Subject: Indian Point 3 Nuclear Power Plant
Docket No. 50-286
Spent Fuel Pool Expansion (TAC 68233)

ATTACHMENT I TO IPN-88-055
RESPONSE TO NRC REQUEST FOR ADDITIONAL
INFORMATION REGARDING THE INDIAN POINT 3
SPENT FUEL POOL EXPANSION

NEW YORK POWER AUTHORITY
INDIAN POINT 3 NUCLEAR POWER PLANT
DOCKET NO. 50-286
DPR-64

N-S OBE Spectrum Ele 54'-6" Indian Point # 3 (Fig H.1.1. 1% Damping)

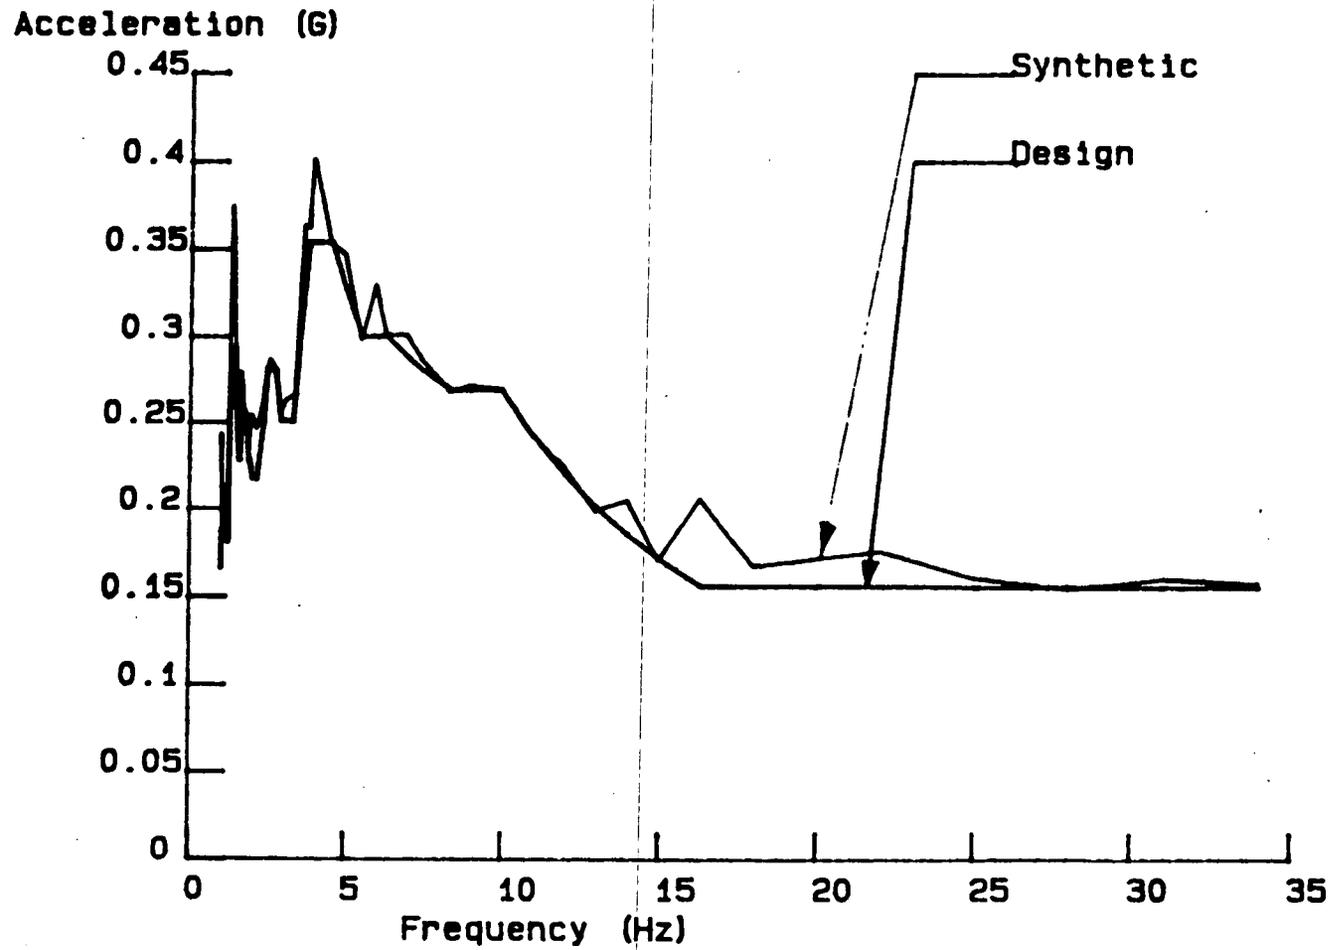
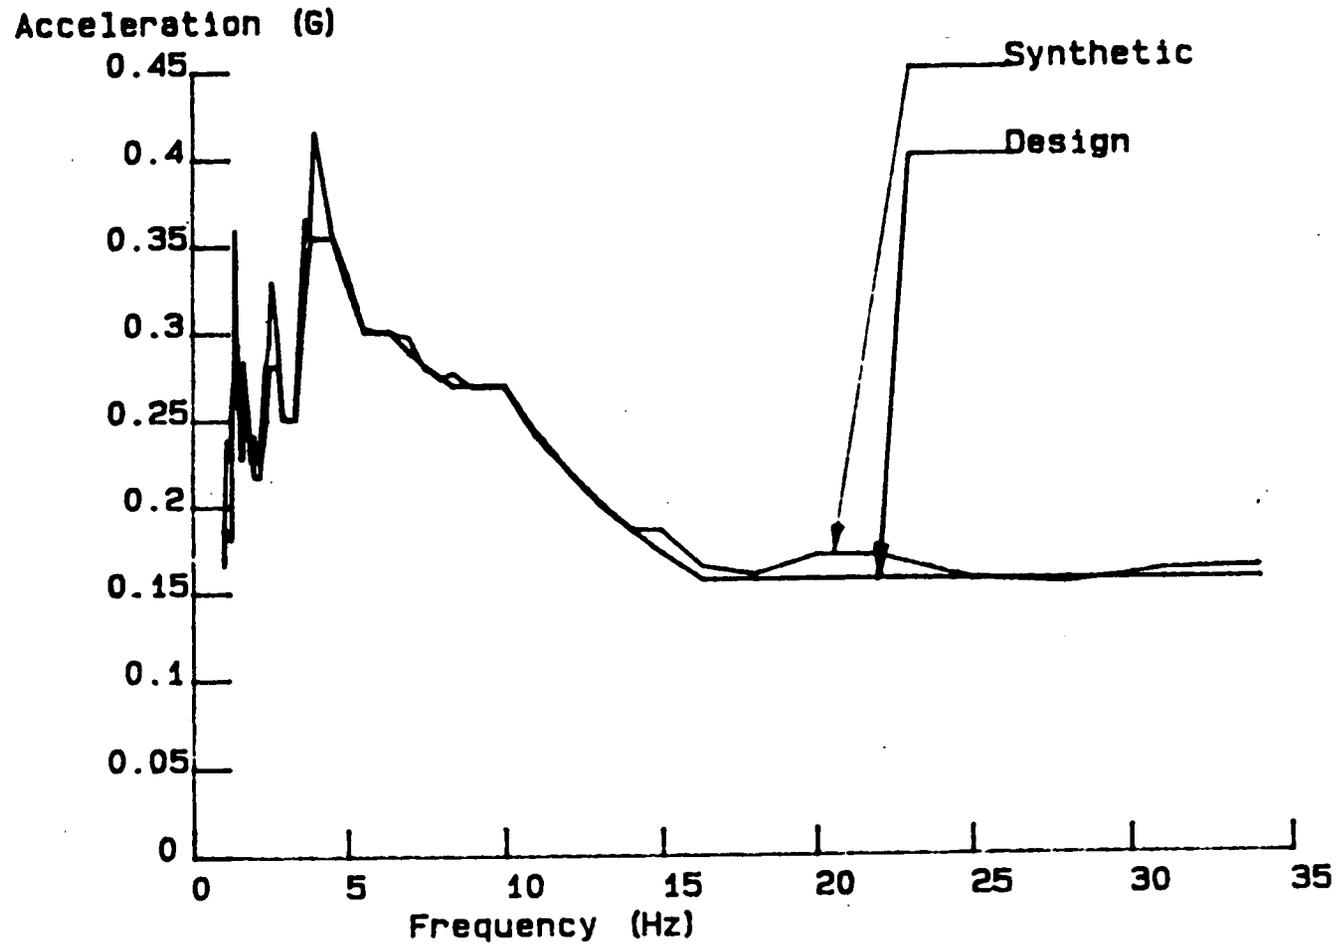
The SSE horizontal time-histories seem to be adequate with respect to the SRP criteria of enveloping. Provide the synthetic time histories corresponding to OBE and show that they meet the SRP enveloping criteria for pertinent damping values.

The Indian Point 3 plant design documents provide the Housner response spectra normalized to 0.15g for DBE (or SSE) earthquakes along E-W and N-S axes for the spent fuel pool. The SSE horizontal time-histories were synthesized from these response spectra over a span of 15.0 seconds at a uniform time interval of 0.01 seconds. In accordance with the Indian Point 3 Final Safety Analysis Report, the OBE time histories for both E-W and N-S axes were obtained by scaling the SSE data by a factor of 2/3rds. These are attached herewith. The design spectra are shown superimposed. As may be noted from these curves, the synthesized time history curves envelope the design spectra, thereby satisfying the SRP enveloping criteria, similar to the SSE curves submitted earlier.

Figure 1

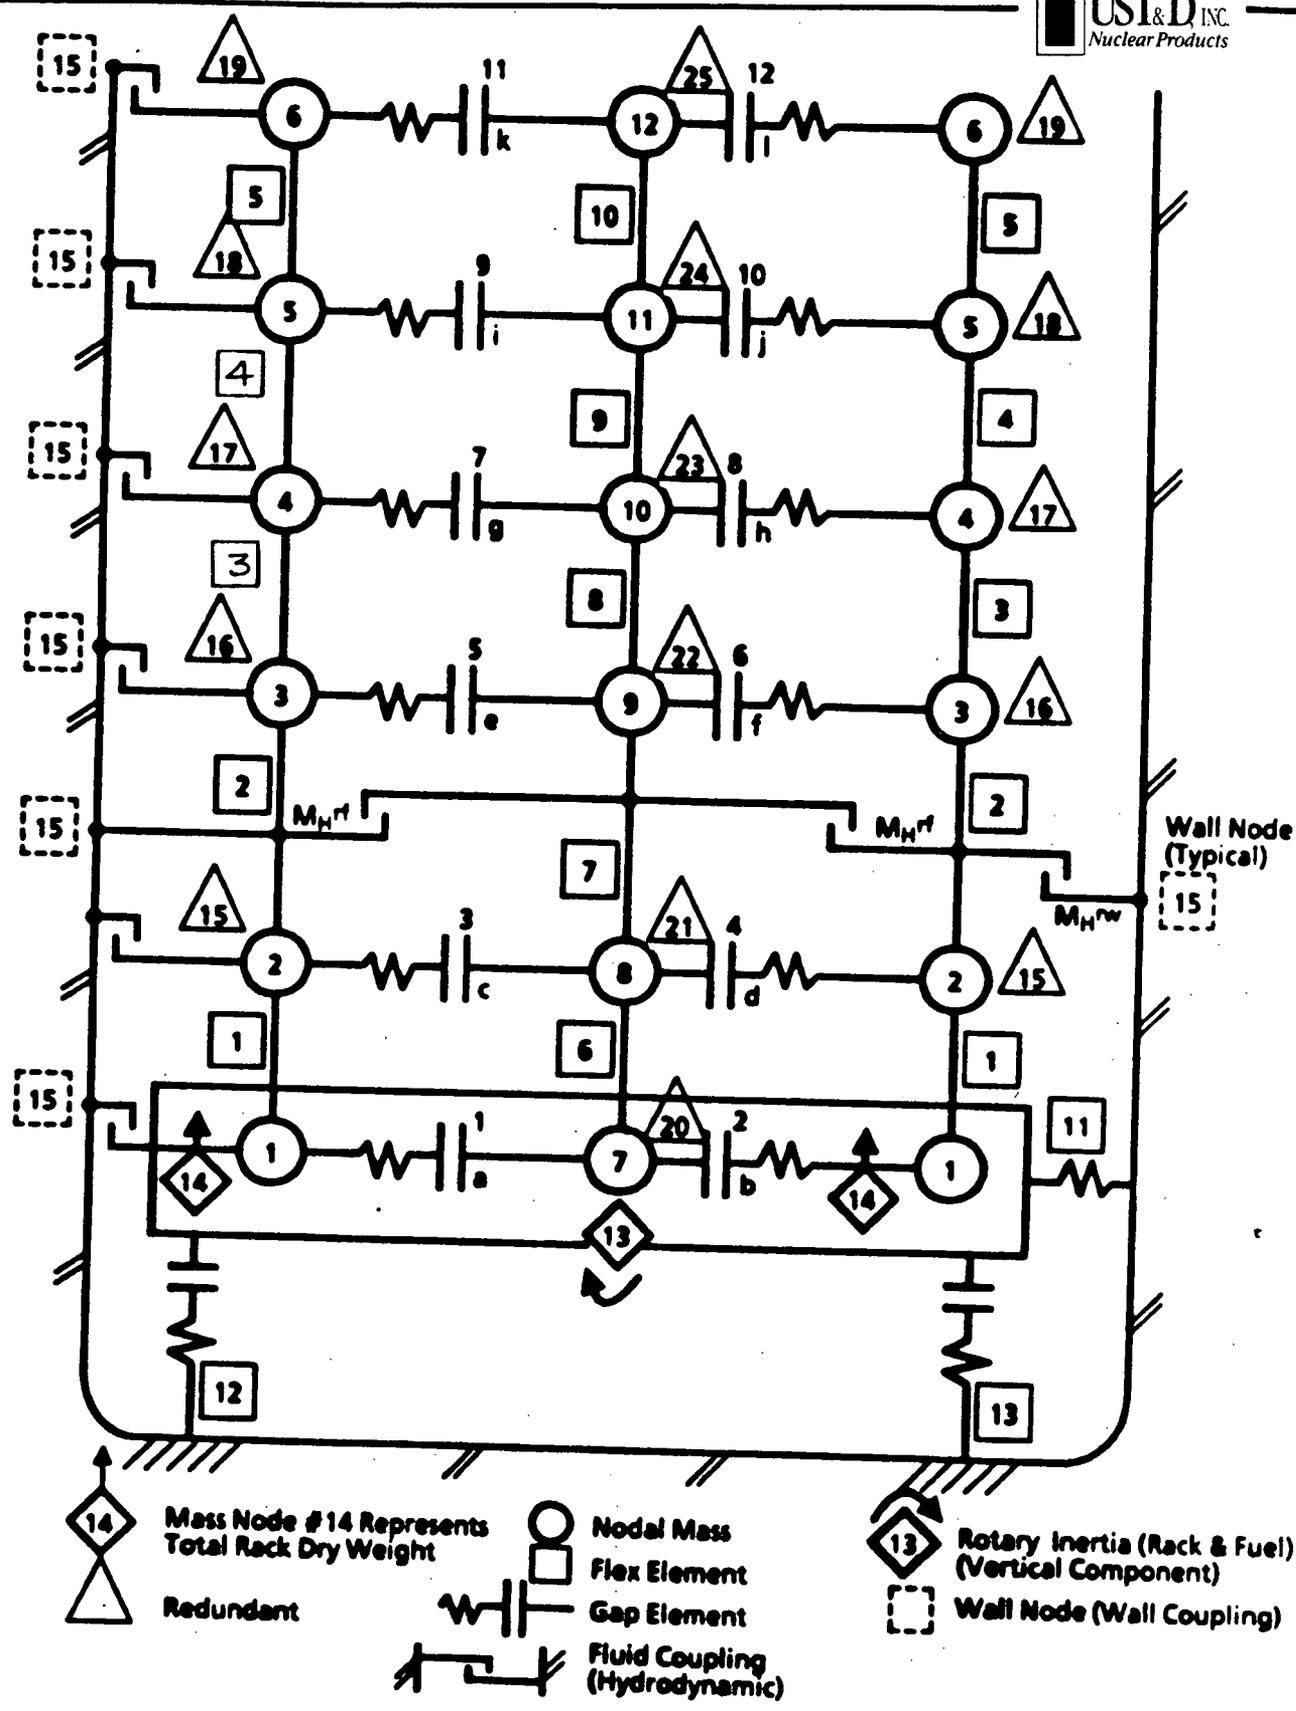
The Seismic Analysis Report and the accompanying papers indicate that numerous computerized analyses were made for single racks and multi-racks. Provide for each analysis case pertinent to Indian Point 3, a summary containing the model, definition of all model parameters (masses, beams, springs, friction elements, fluid coupling coefficients, gaps, etc.), the value of the parameters and the source or method used to develop each parameter. In addition, a summary of the results (forces and displacements) for each analysis case should be presented in a tabular form which would assist in interpreting the rack response (rather than reviewing computer output), permit verification of assumptions made (such as the racks move in phase), and allow comparisons among the different analysis cases.

For multi-rack analysis credit was taken of the presence of liquid between racks and the hydrodynamic coupling generated due to it. The analytical procedure was similar to a single rack. Fig. 1 shows a mathematical model of a rack with multiple cells in it, where

Beams: Beam-elements connect the lumped-masses of a single cell. As shown in Fig. 1 each has (for example 132 rack unconsolidated fuel, E-W direction) $L = 33.08$ in and $EI = 9.37 E6$ lb/in, fuel $EI = 3.04 E3$ lb/in. These values were calculated from structural properties of the elements.

This analysis was performed for the math model shown in Fig. 1.

Max. Tensile Stress = 21,810 $\frac{\text{lbs}}{\text{in}^2}$

Max. Sliding (SSE) = 0.3027 inches

Max. Lift-off = 0.01 inches
